**GOVERNMENT OF THE DISTRICT OF COLUMBIA
DEPARTMENT OF TRANSPORTATION**

MEMORANDUM

SUBJECT: Zoning Commission Case No. 13-09 – Stanton Square & Commons

Figure 5 Existing Pedestrian Infrastructure Evaluation

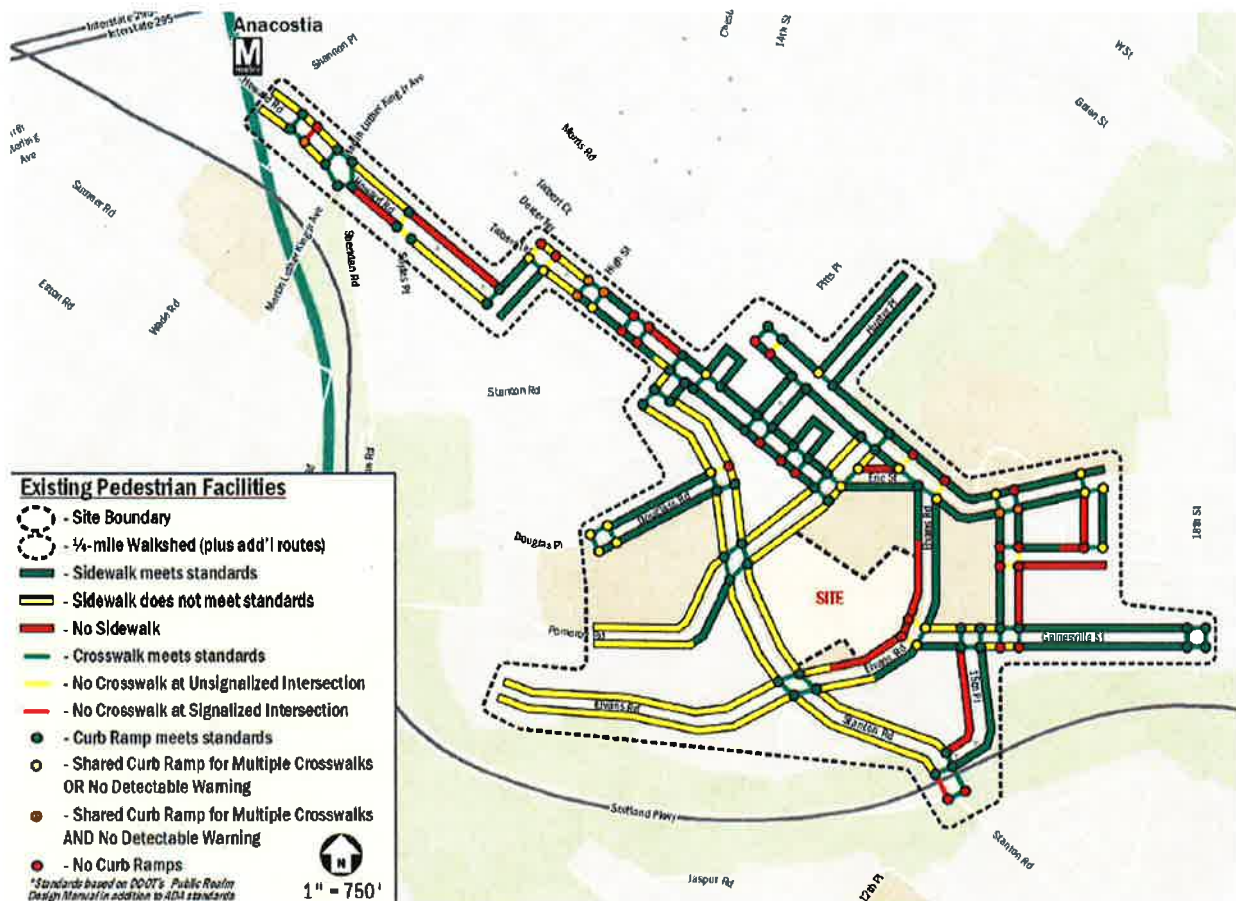
The Applicant performed an analysis of existing pedestrian infrastructure in the vicinity of the site and found missing and substandard pedestrian facilities. Immediately adjacent to the site, the analysis revealed missing sidewalks along the north side of Elvans Road and narrow sidewalks along Stanton Road and Pomeroy Road that lack tree boxes and a planting strip. Tree boxes and planting strips create a safer and more pleasant pedestrian environment by providing a "shy zone" that allows for separation between pedestrians and moving vehicles. The planting strip and tree boxes also provide an opportunity for increased street trees, which further enhance the pedestrian environment.

The Applicant's analysis found substandard pedestrian facilities within close proximity to the site, including at the intersections of Elvans Road & Gainesville Street and Elvans Road & Morris Road & Erie Street. These intersections are expected to experience high pedestrian volumes due to the action as they serve important connections to nearby bus stops and other destinations.

The Applicant proposes mitigations to improve substandard pedestrian facilities at two off-site intersections – Elvans Road & Gainesville Street and Elvans Road & Morris Road & Erie Street. Specifically, the Applicant proposes improved marking and signage, including stop bars, crosswalks, and curb ramps to meet DDOT and ADA standards. The Applicant cautions that improvements have not been designed and complications in design could stem from non-transportation issues such as utility pole relocation costs, conflicts with sewer/stormwater infrastructure, and/or right-of-way limitations. DDOT understands the possibility of high-cost complications and will work with the Applicant through the public space permitting process to focus on high-impact, lower-cost improvements that can be made to these intersections. If acceptable designs for one or both of the highlighted intersections cannot be developed, the Applicant should ensure that at least two study area intersections are improved.
